## Engineering and Regulations – Witness Statement

**From:** Tyler Bauman, B.Eng., P.Eng., Water Resources Engineer (Flood Management)  
**Subject:** Engineering Opinion related to development within the floodplain at 141 Peter Street

**Technical Review Memorandum**  
**Western Annex Lands, Town of Perth**  
**June 22, 2023**

### Western Annex Lands, Town of Perth – Response to JFSA Comments

**Figure 1**  
**Western Annex Lands**  
**Proposed Floodplain**  
**Amendment - RVCA**

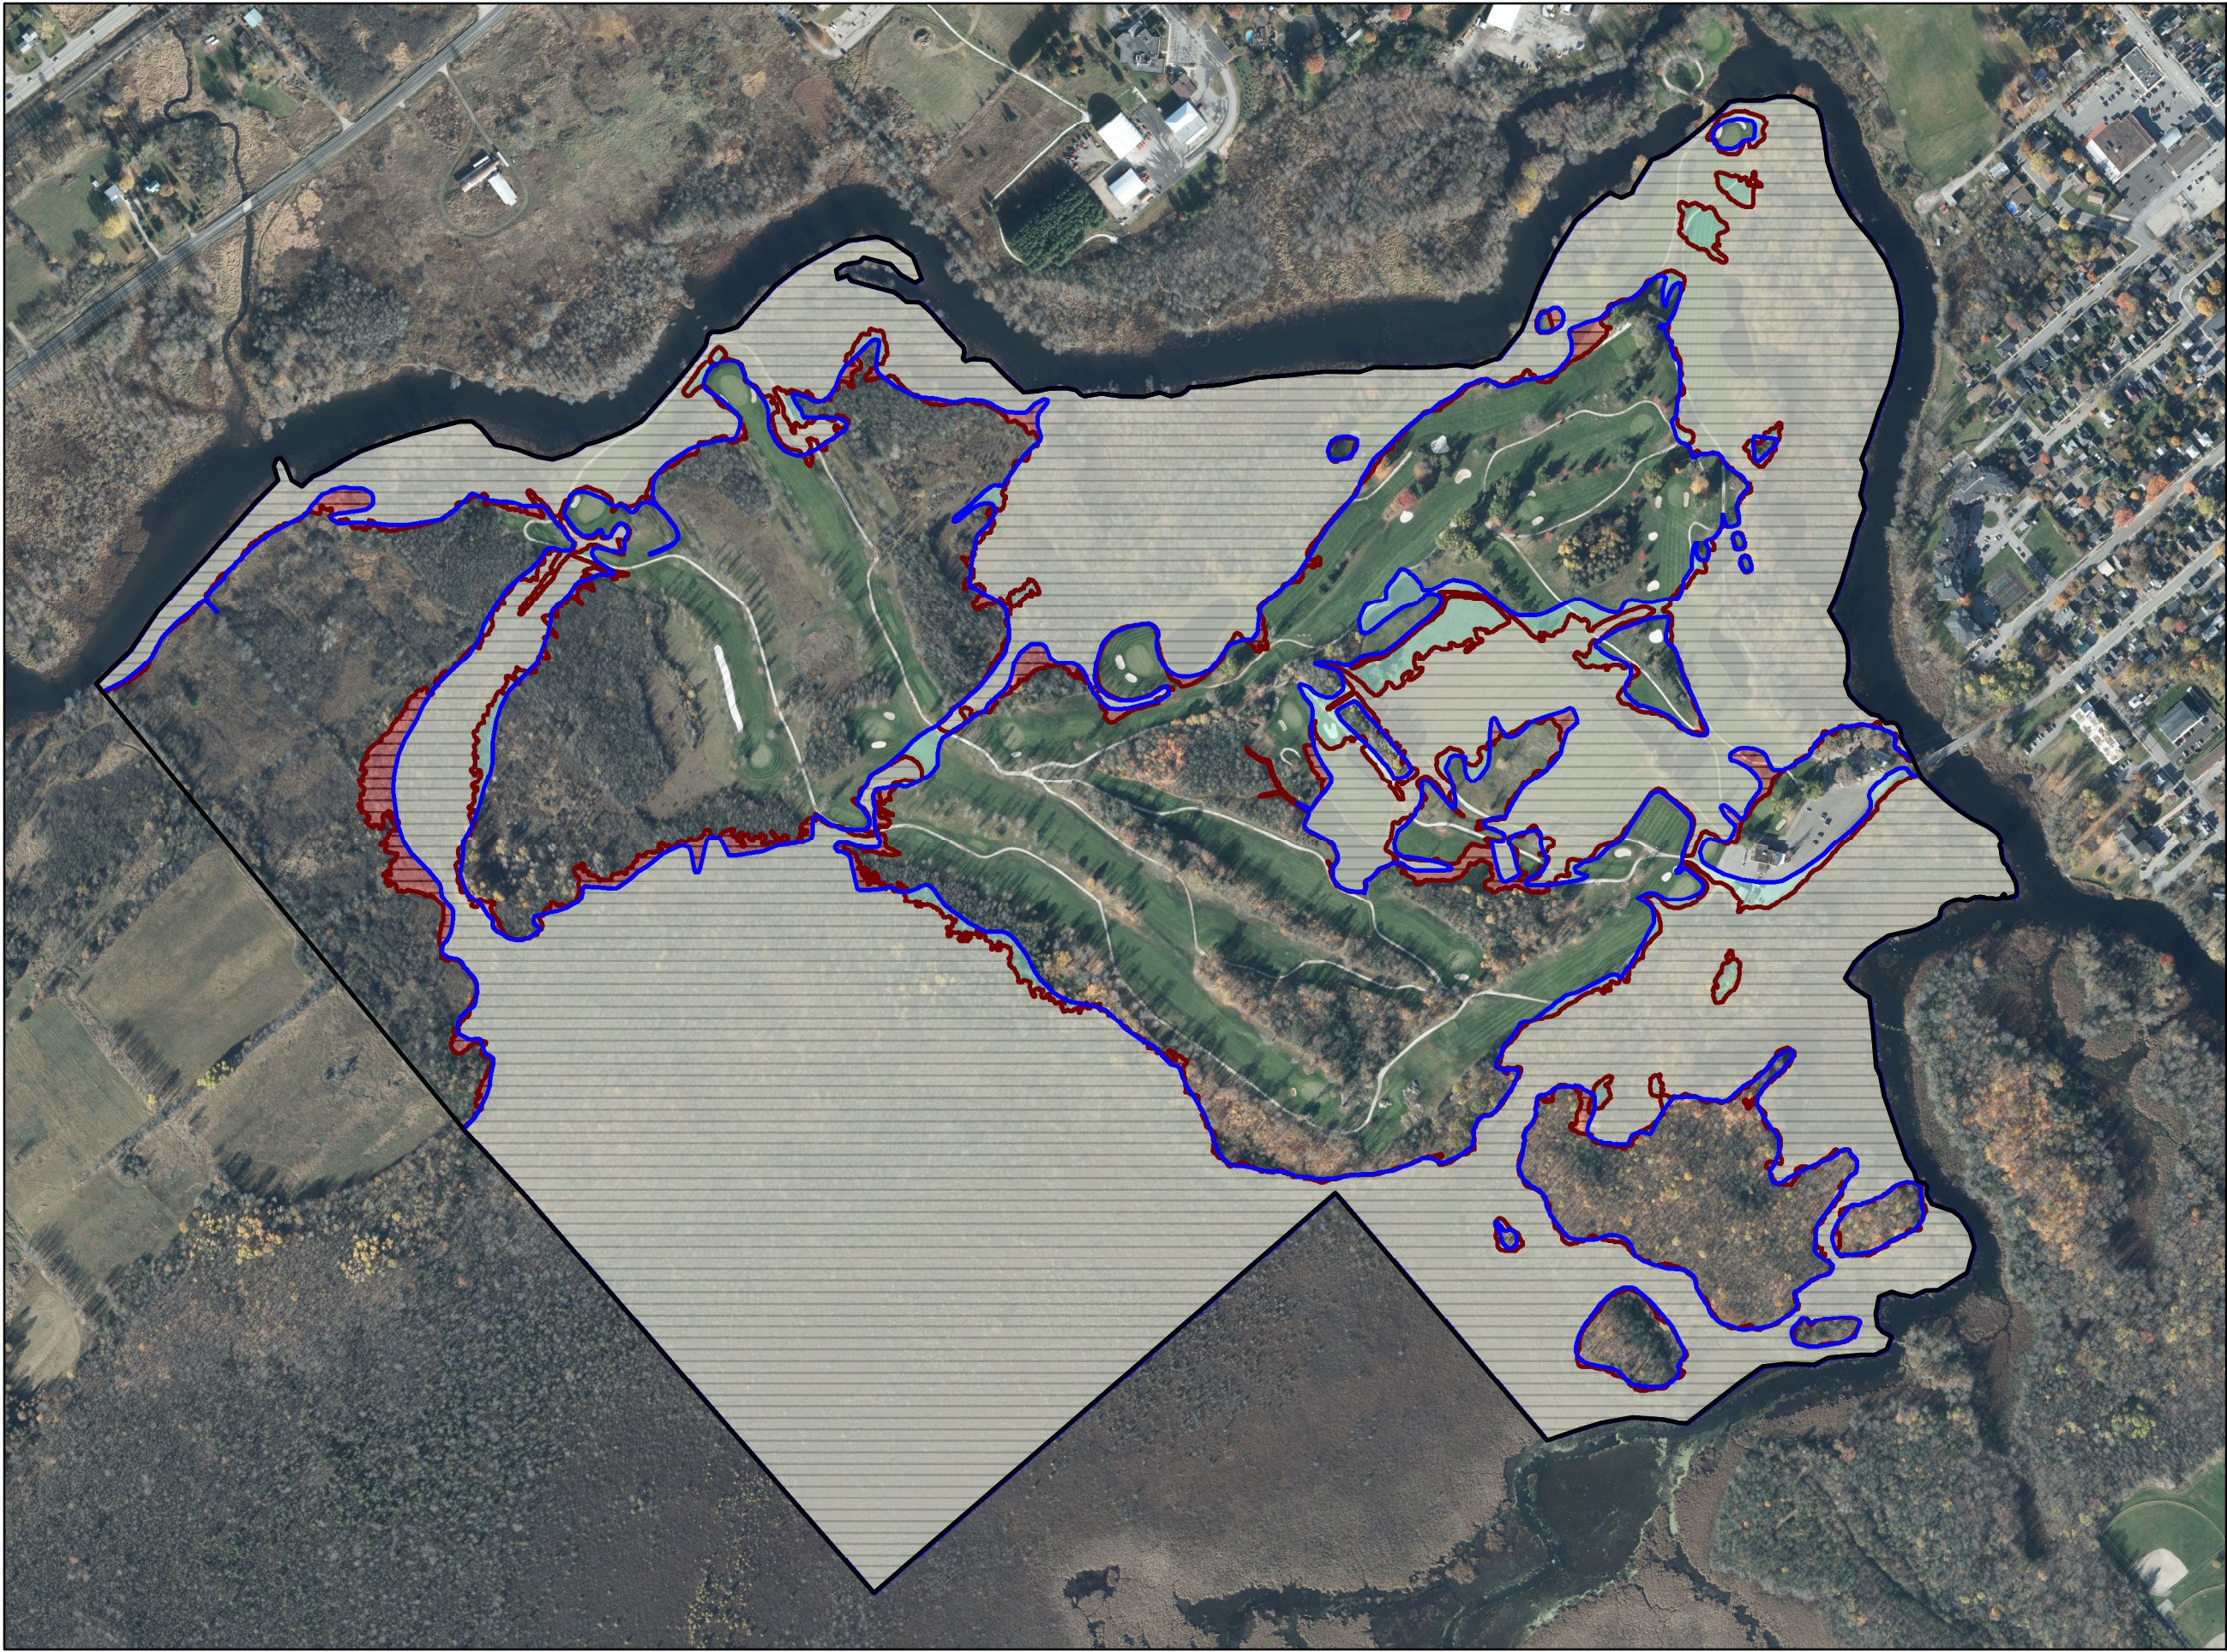
7. The RVCA has delineated an alternative proposed floodplain amendment based on the 2022 LiDAR-derived topography. The proposed extents can be examined in Figure 1. The differences between the current regulatory floodplain and the RVCA's proposed amendment can be seen in Figure 2. These figures provide the basis for the RVCA's disagreement with certain JFSA statements:

- a. The RVCA considers the floodplain banks to be well-defined in select areas, instead of generally true as suggested by JFSA. This distinction is important, as JFSA's language suggests the floodplain to be more well confined than RVCA's mapping suggests.

- b. The RVCA has determined that two overland connections between the Tay River and Grants Creek exist on the subject lands, facilitated by hydraulic connections confirmed by JFSA through surveyed invert elevations noted within Figure C3 of the Hydrologic and Hydraulic Conditions Report (February 2023). These overland connections would need to be maintained under Section 2.0 Policies Regarding the Placing of Fill of the RVCA's Interim Policy for the Administration and Implementation of Ontario Regulation 41/24.

**The extent of the current regulatory floodplain would be largely unchanged through the proposed floodplain amendment based on the 2022 LiDAR-derived topography. Overland connections exist between the Tay River and Grants Creek through the unconfined floodplain on the subject lands.**
